BLDG PERMIT NO. 64258

PLANNING CLEARANCE
 (Single Family Residential and Accessory Structures)
 Grand Junction Community Development Department

► APPROVAL FOR BUILDING PERMIT ◀
Ridges Architectural Control Committee (ACCO)

Job No. CV-6
 Builder or Homeowner
FreeStyle, INC.
 Ridges Filing No. 6
 Block 9 Lot 6 - CV 6
 Pages Submitted _____
 Date Submitted _____

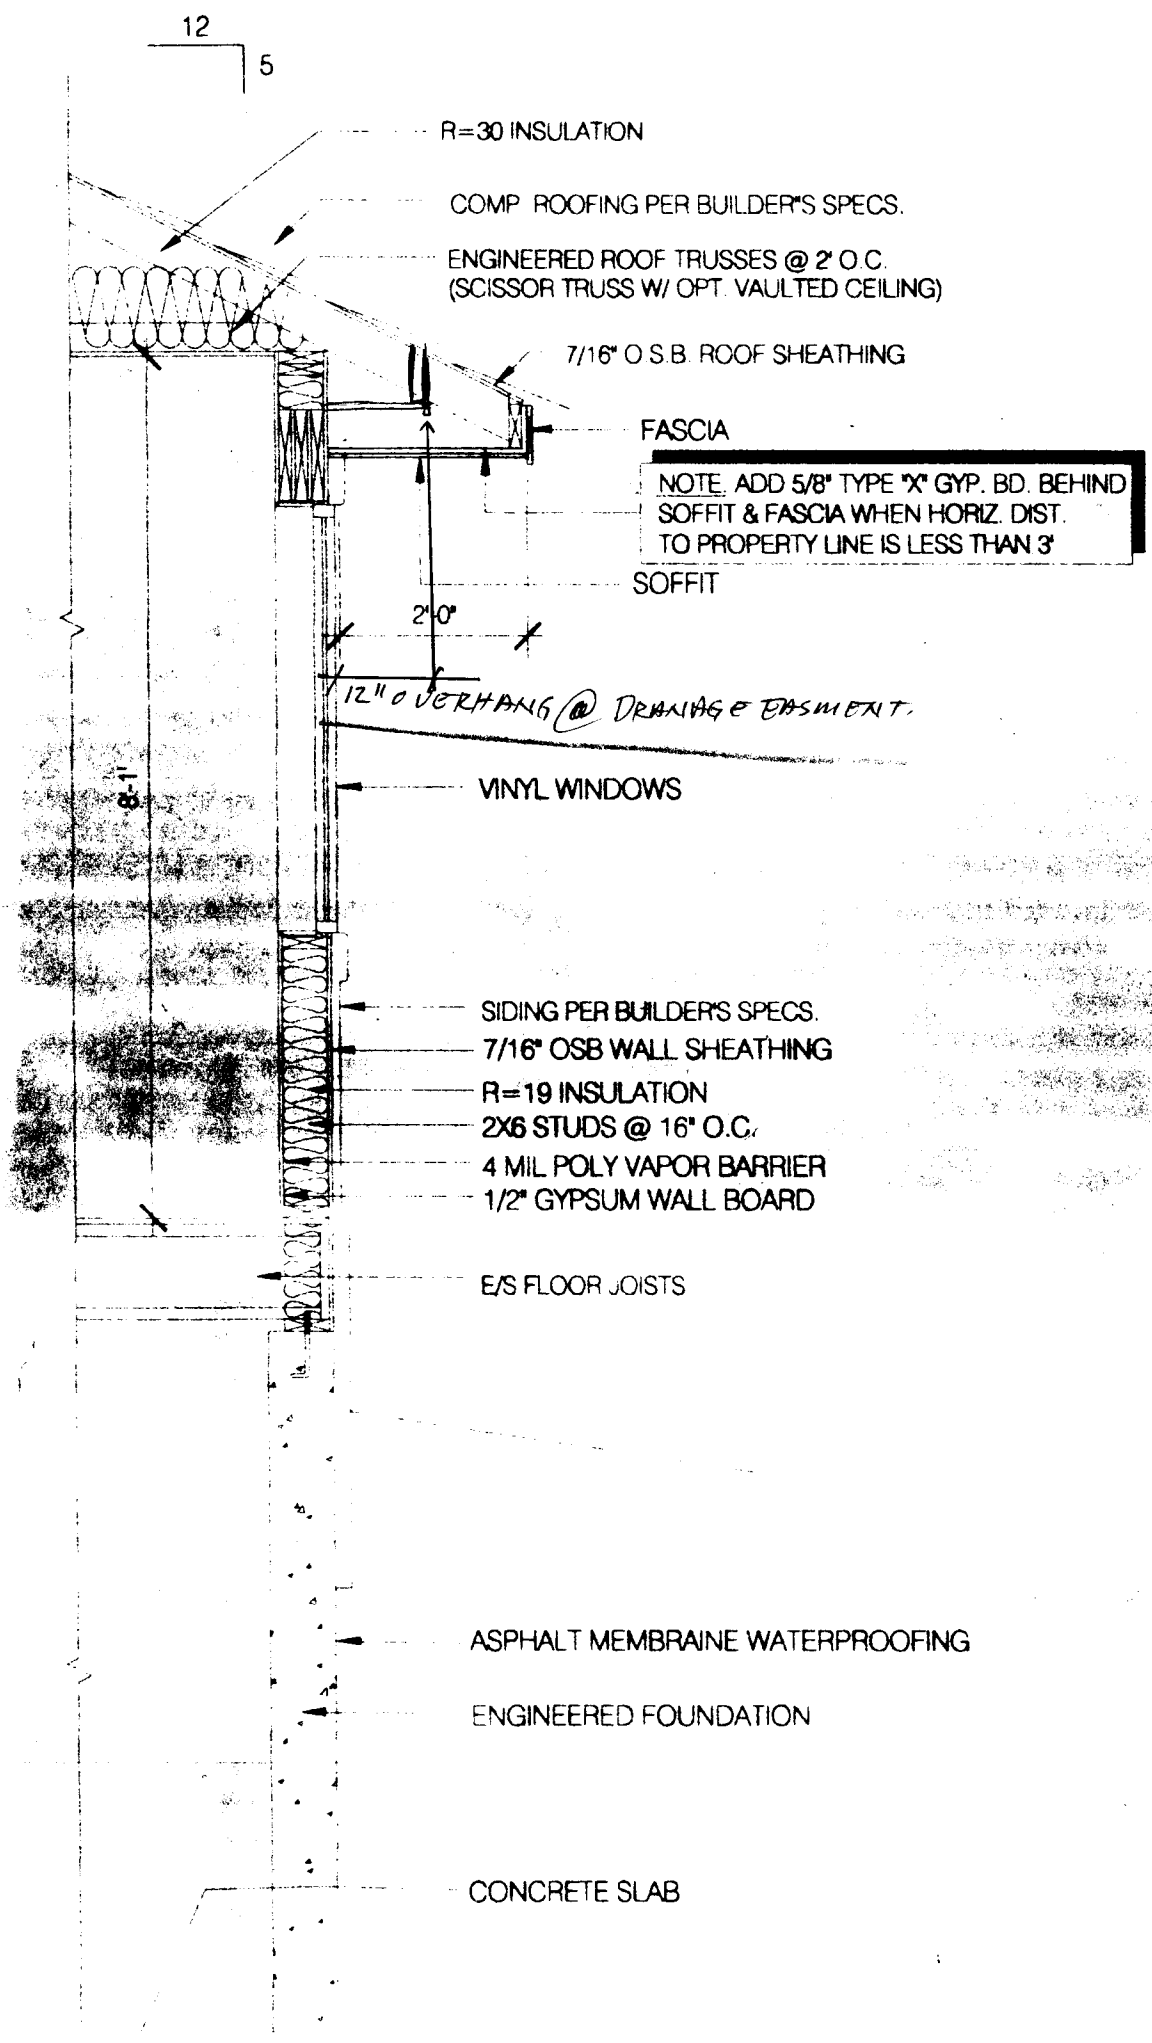
ZONE PR-4 Maximum coverage of lot by structures _____
 SETBACKS: Front 10' from property line (PL) Parking Req'mt 2
 or _____ from center of ROW, whichever is greater
 * ~~10'~~ measured to foundation wall. Special Conditions bdg separation determined
 Side 0-10' from PL Rear 10' from PL by bldg code. Roof drainage cannot
 Maximum Height 25' drain onto adjacent property.
 CENS.T. _____ T.ZONE _____ ANN# _____

DRIVEWAY LOCATION
O.K.
Kl Ashbeck
(PRIVATE STREET)
